Architect Name and Address	BAY LAKE, FLORIDA 32830
G.C Name and Address	
Project Name and Address

Scope Description	AREA	GROUP	SERIES
			COVER SHEET

Drawn By	Date
HD	09/27/19
Project #	Submittal #
3403	01
Drawing #	
00CS

1 PLAN VIEW - DINING ROOM 103
SCALE: 3/4"=1'-0" ARCH REF: E2/A-321

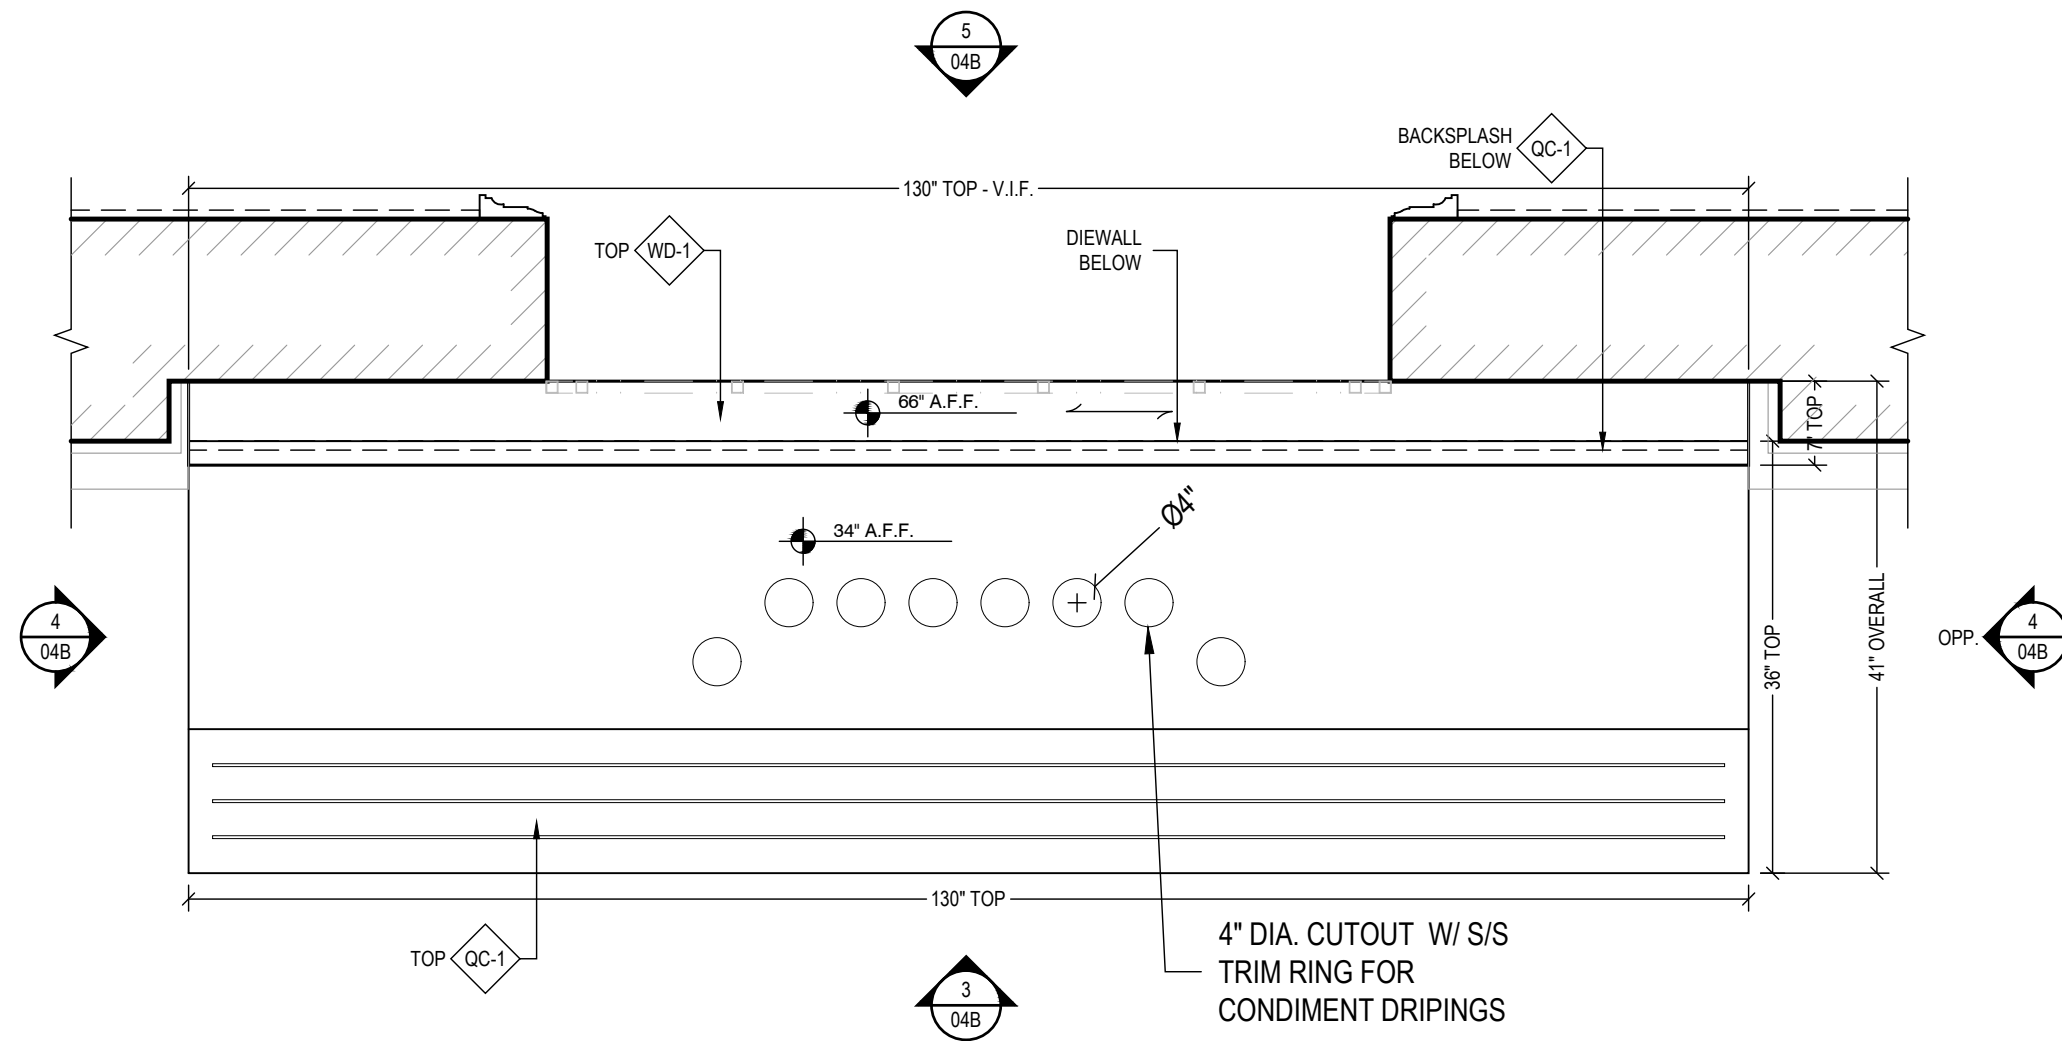
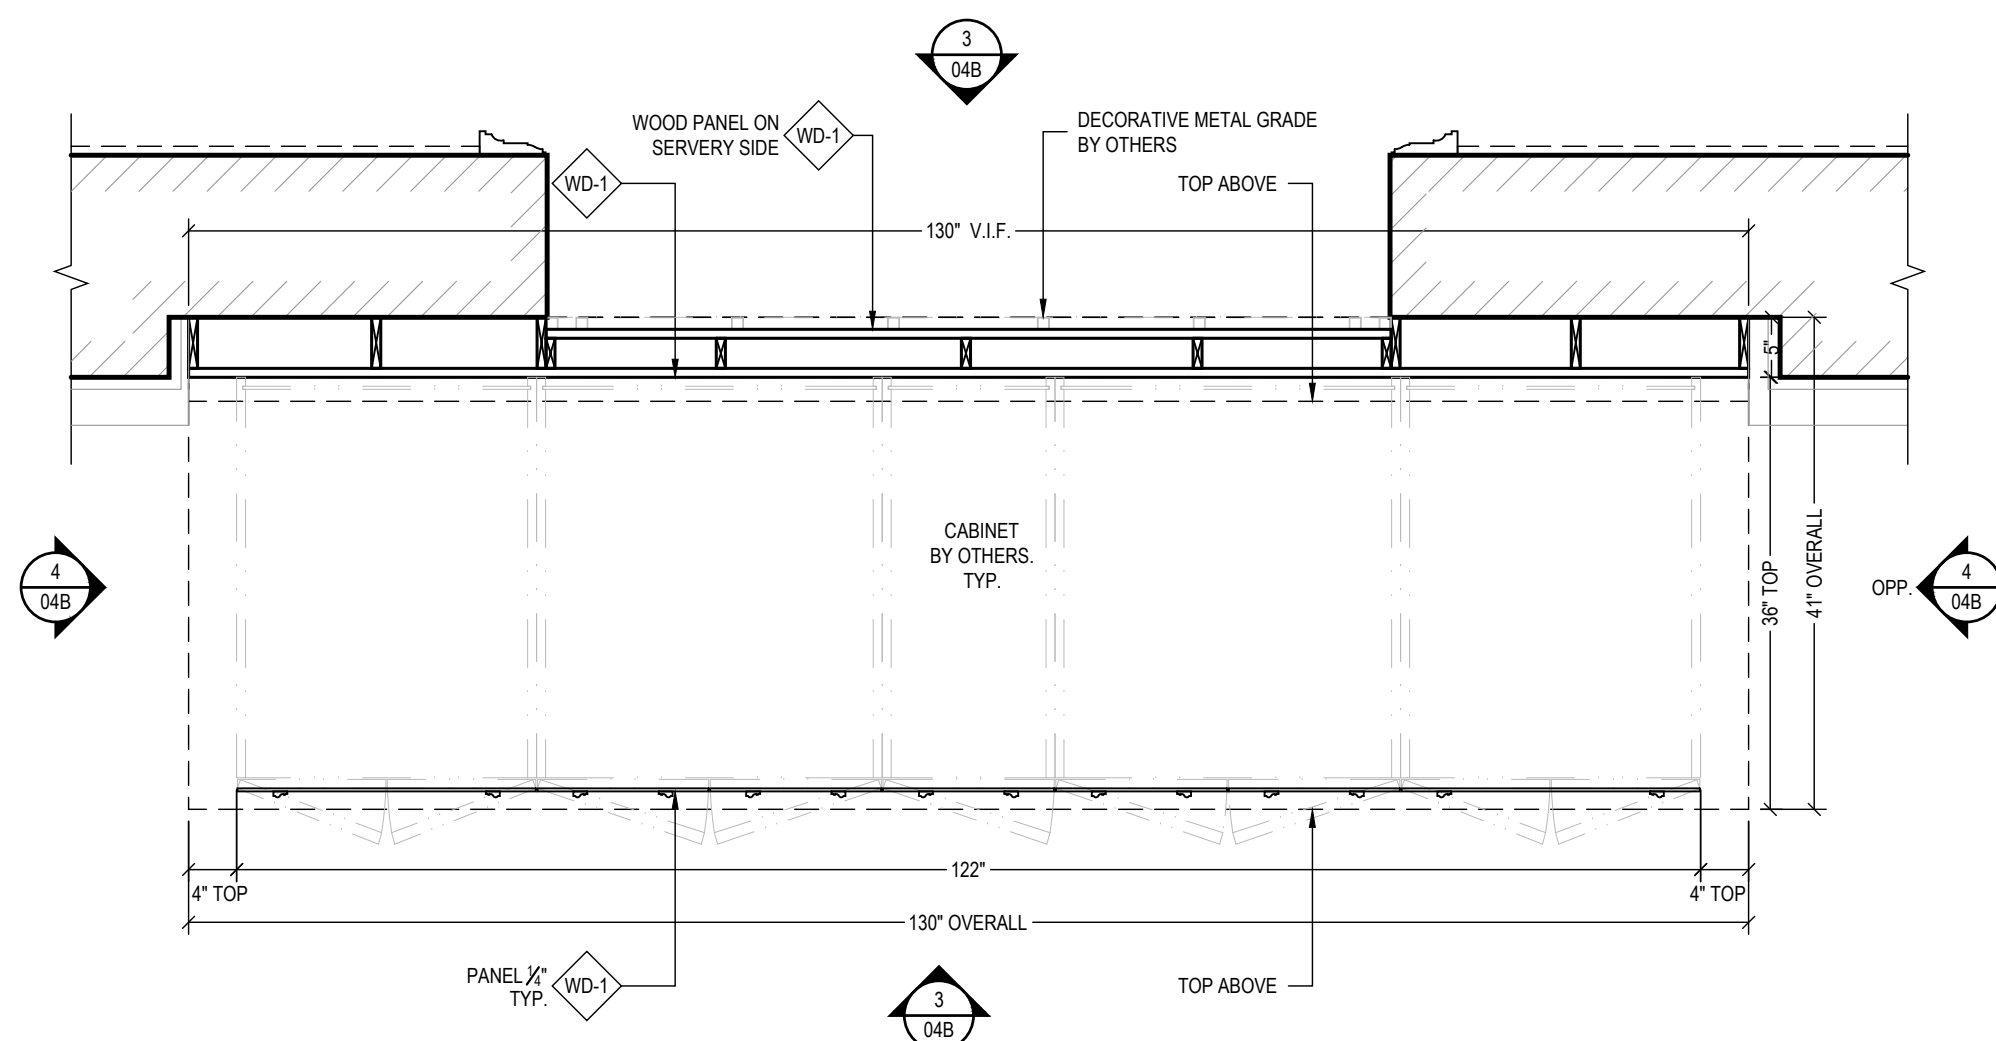
NOTE TO ARCHITECT:
THE PROVIDED FOOD SERVICE DRAWING
INDICATE TRASH CUTOUTS ON BOTH ENDS
OF COUNTER NOT SHOWN ON ARCH.
DRAWING. PLEASE ADVISE.

4 SIDE ELEVATION - DINING ROOM 103
 SCALE: 3/4"=1'-0" ARCH REF: NONE

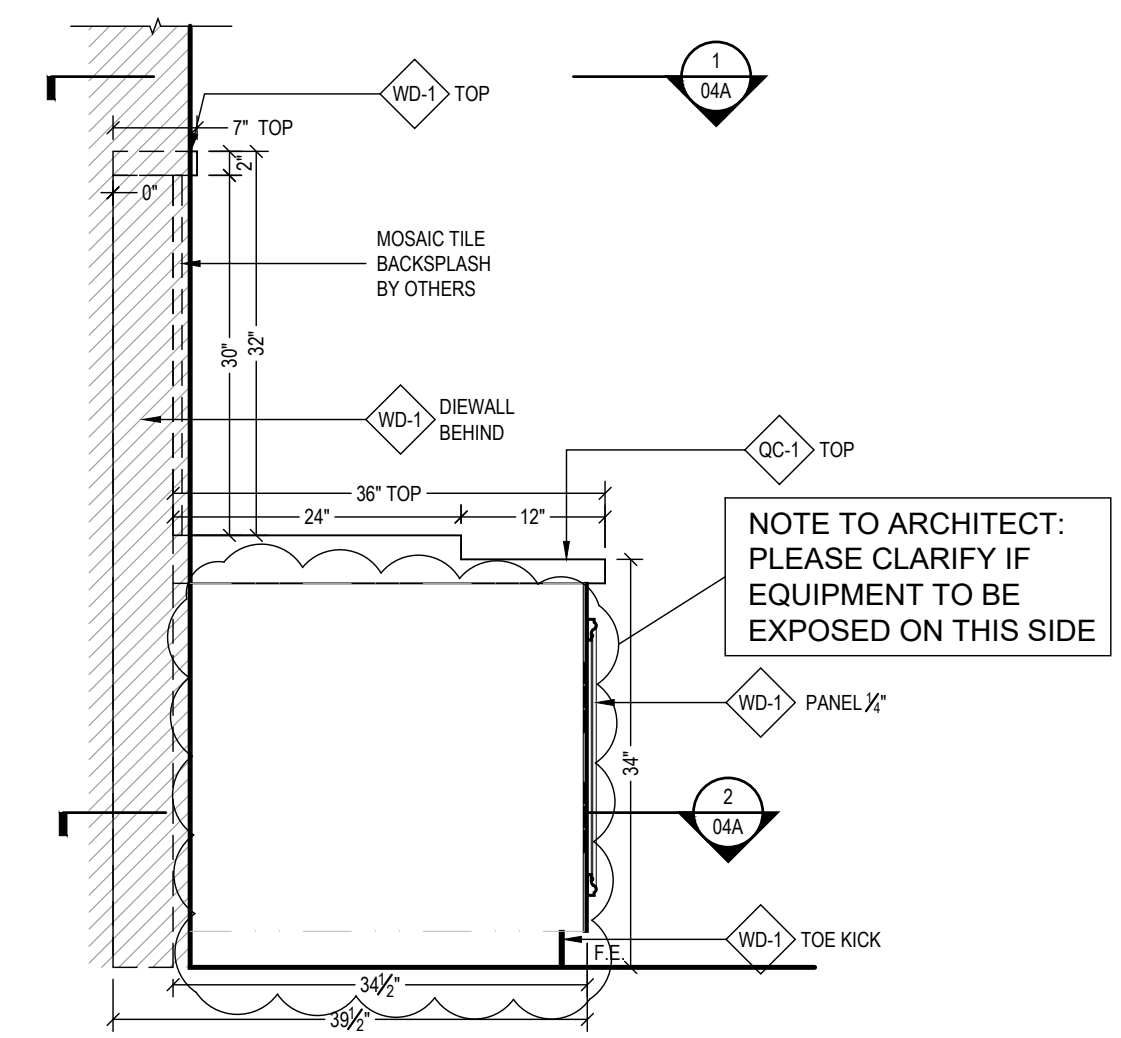
NOTE TO ARCHITECT:
 ARCH. ELEVATION IS NOT CONSISTANT WITH
 ELEVATION PROVIDED BY FOOD SERVICE
 EQUIPMENT DRAWINGS. DRAWN TO MATCH
 ARCH. ELEVATION.PLEASE VERIFY.

5 ELEVATION - DINING ROOM 103
 SCALE: 3/4"=1'-0" ARCH REF: E4/A-321

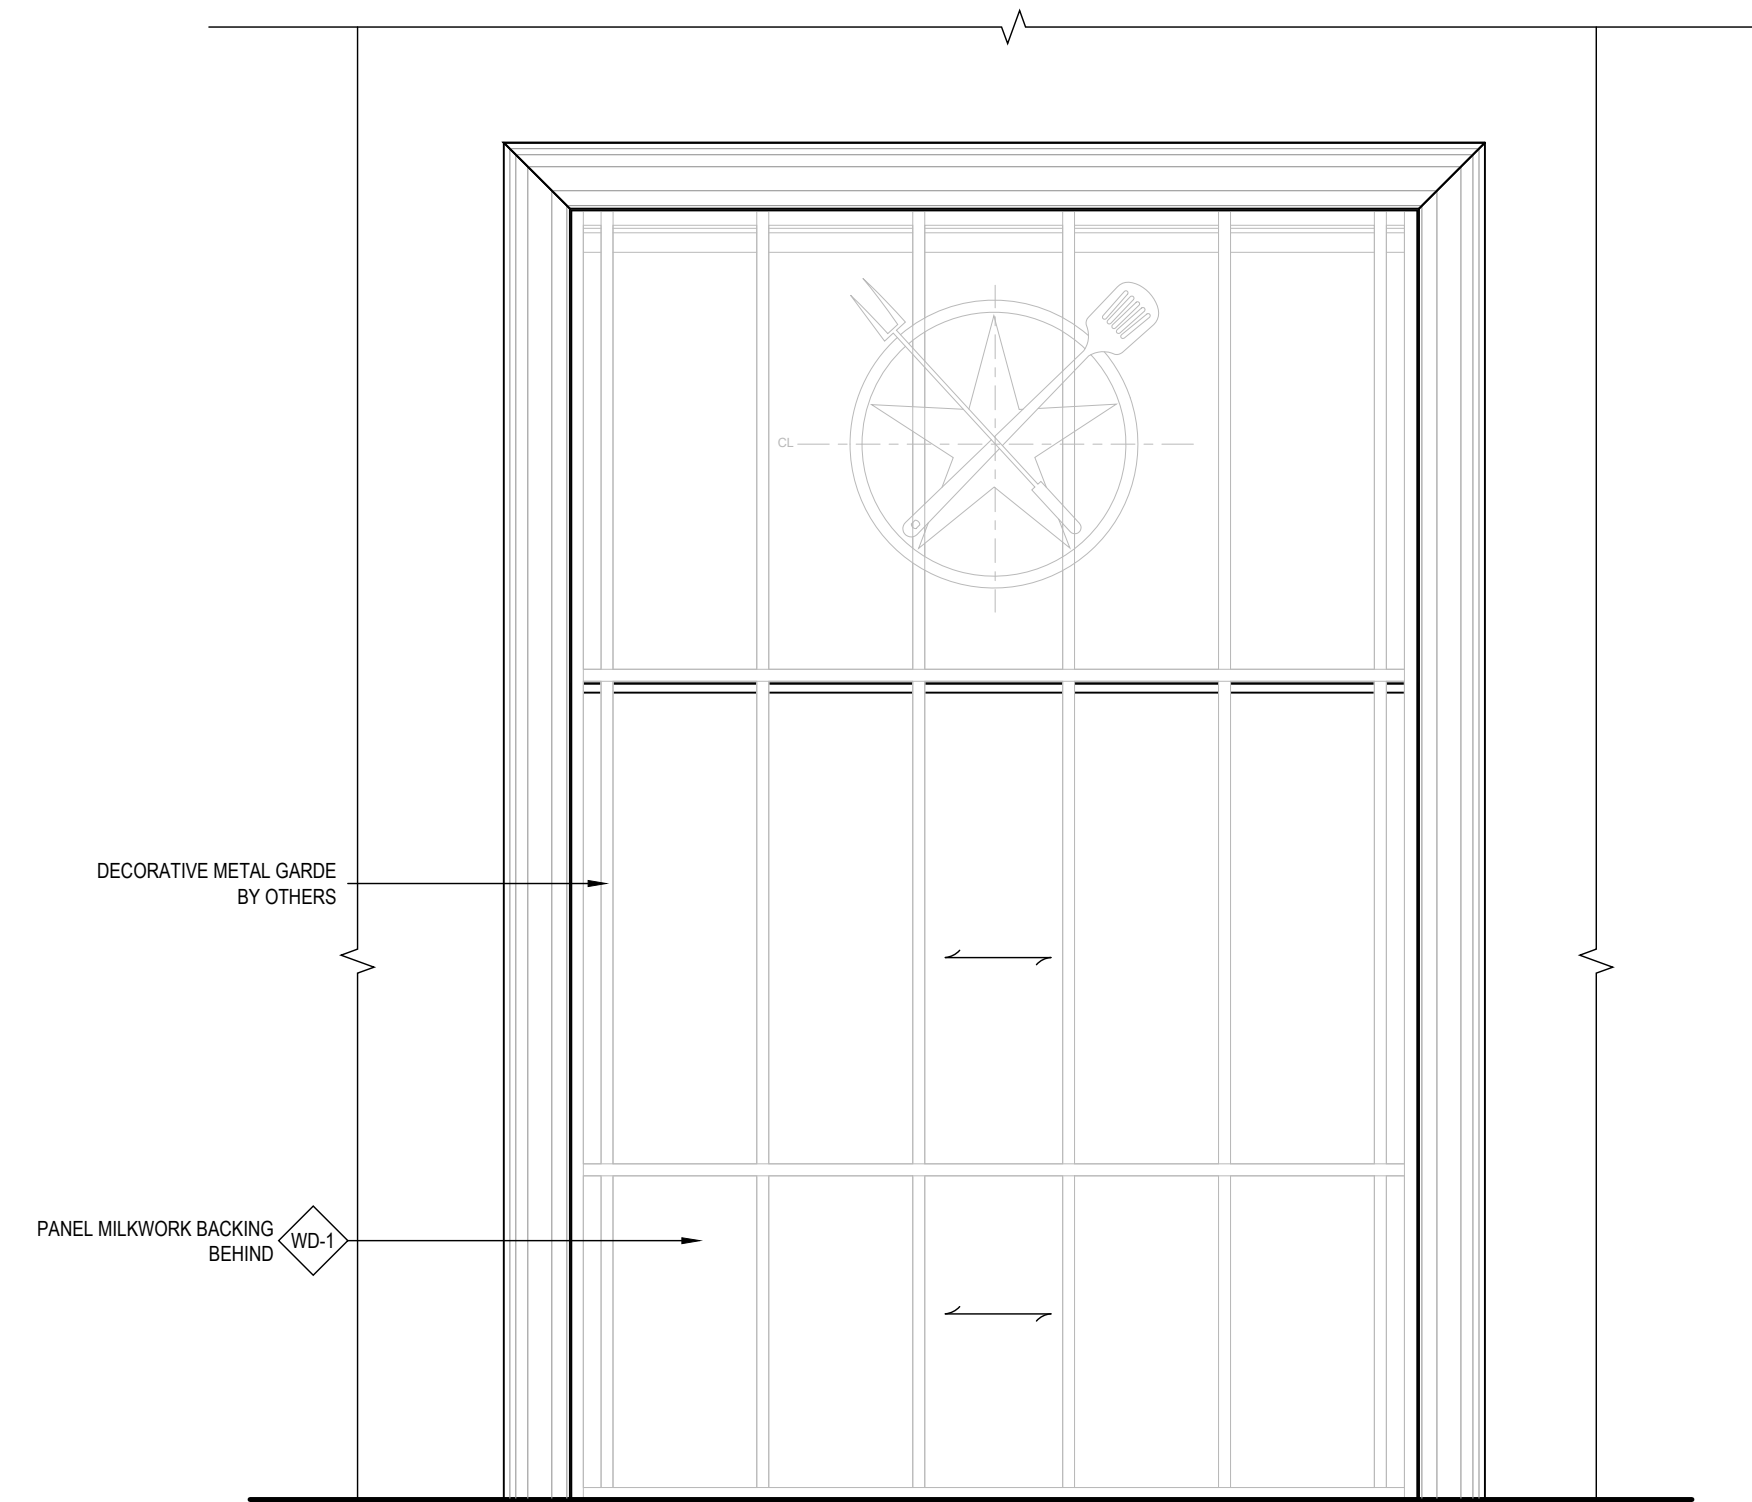
NOTE TO ARCHITECT:
 PLEASE CLARIFY IF
 EQUIPMENT TO BE
 EXPOSED ON THIS SIDE
